questions on X-178 plan-as-presented-by Eversource’s PAC presentation document:

Project Locations

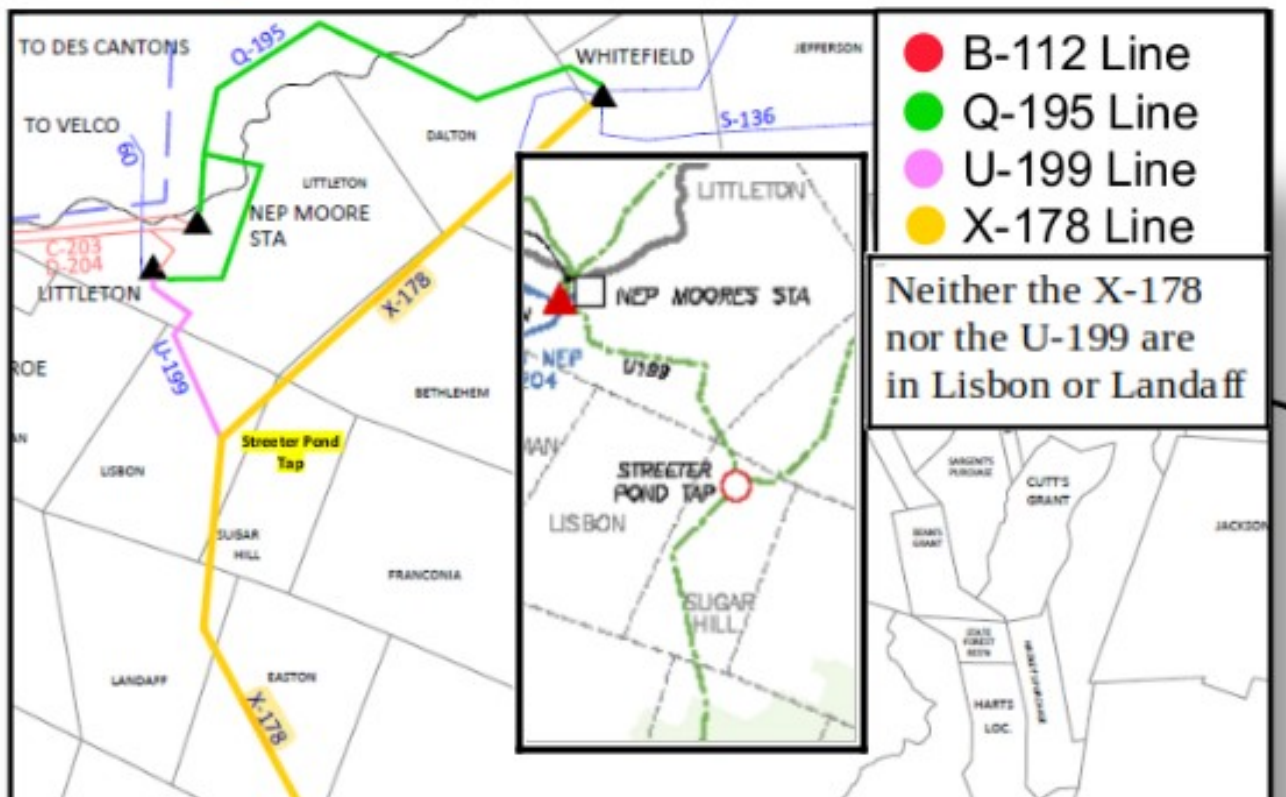
Page 4: Your project location map incorrectly shows the X-178 running through Landaff and Lisbon, rather than bisecting Sugar Hill. This map also shows the U-199 running through Lisbon, which is incorrect. Below, I have added an inset showing the correct routes.

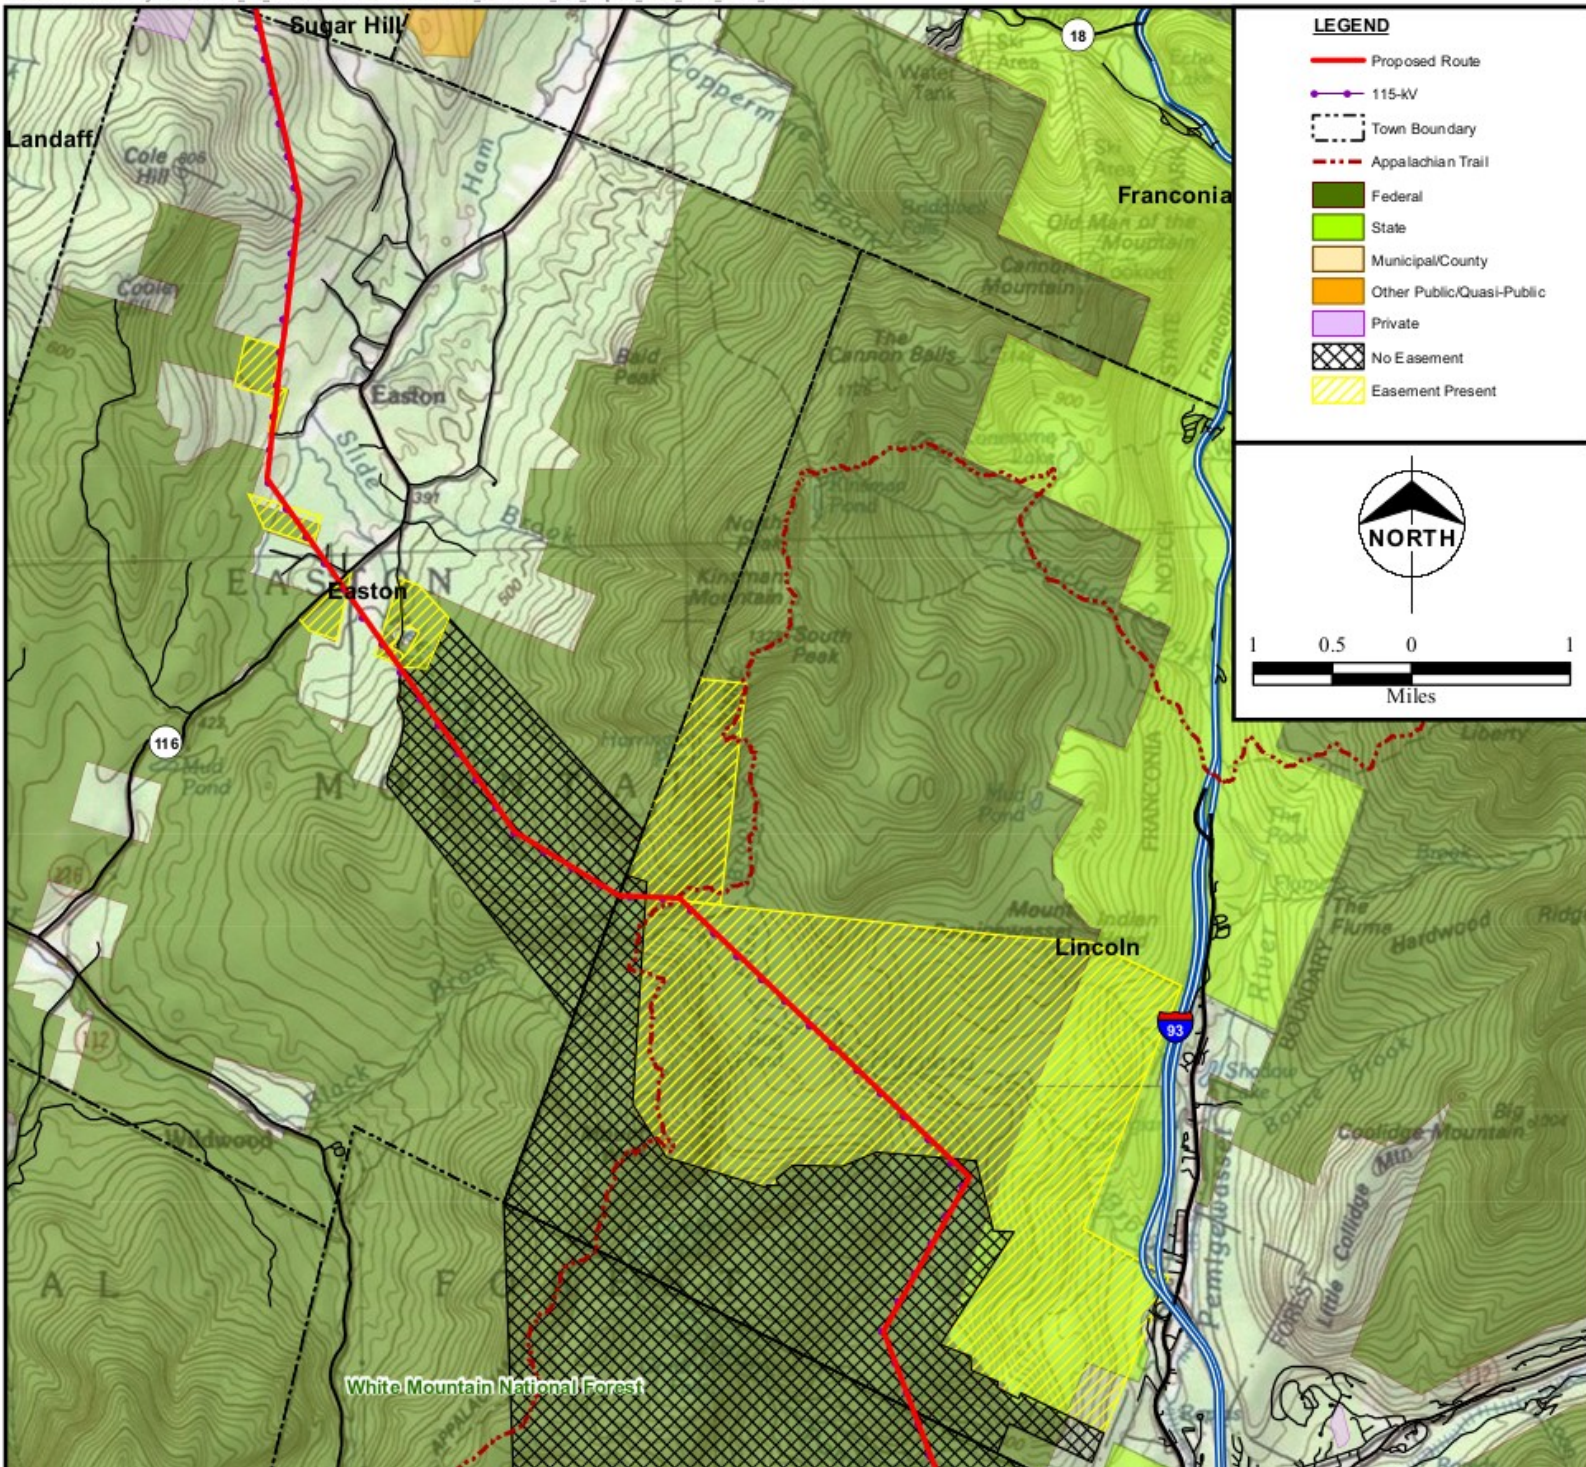
“Right-of-way intersects with Appalachian Trail” is incorrect. Eversource has no right-of-way, it has an easement.

Why does Eversource fail to mention that it has no easement through a significant section of White Mountain National Forest which is also a Roadless area?
